**BROWNS FERRY NUCLEAR PLANT (BFN) - UNITS 1, 2, and 3 -
EMERGENCY PLAN IMPLEMENTING PROCEDURE (EPIP) REVISIONS**

TVA is submitting this notification in accordance with the requirements of 10 CFR Part 50, Appendix E, Section V. Specifically, several EPIPs were revised: (1) EPIP-2, Revision 25; (2) EPIP-3, Revision 28; (3) EPIP-4, Revision 27; (4) EPIP-5, Revision 32; (5) EPIP-6, Revision 22; (6) EPIP-7, Revision 20; (7) EPIP-12, Revision 0; (8) EPIP-13, Revision 9; and (9) EPIP-14, Revision 17. The revisions have an effective date of October 29, 2002. Additionally, EPIP 17 and EPIP-20 were canceled on October 29, 2002; therefore, please remove EPIP-17 Revision 25 and EPIP-20 Revision 9.

EMERGENCY PLAN IMPLEMENTING PROCEDURE (EPIP) REVISION
EPIP-2, EPIP-3, EPIP-4, EPIP-5, EPIP-6, EPIP-7, EPIP-12,
EPIP-13, EPIP-14, EPIP-17 and EPIP-20

ATTACHMENT C (Page 1 of 1)
PROTECTIVE ACTION RECOMMENDATIONS

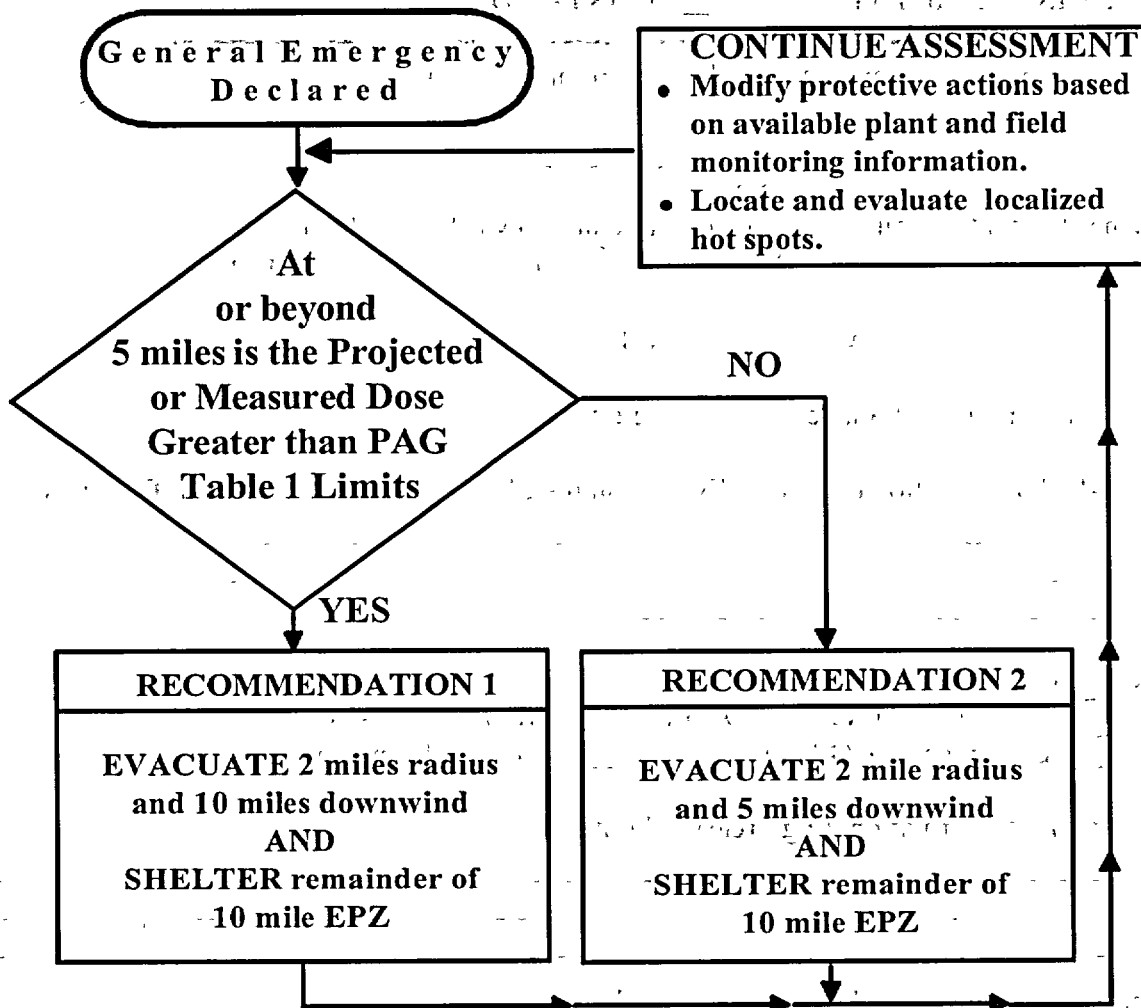
- Page 10 - revised to update information supporting Unit 1 Operator actions regarding ERO staffing support.
 - Page 11 - revised Protective Action Recommendation Flowchart
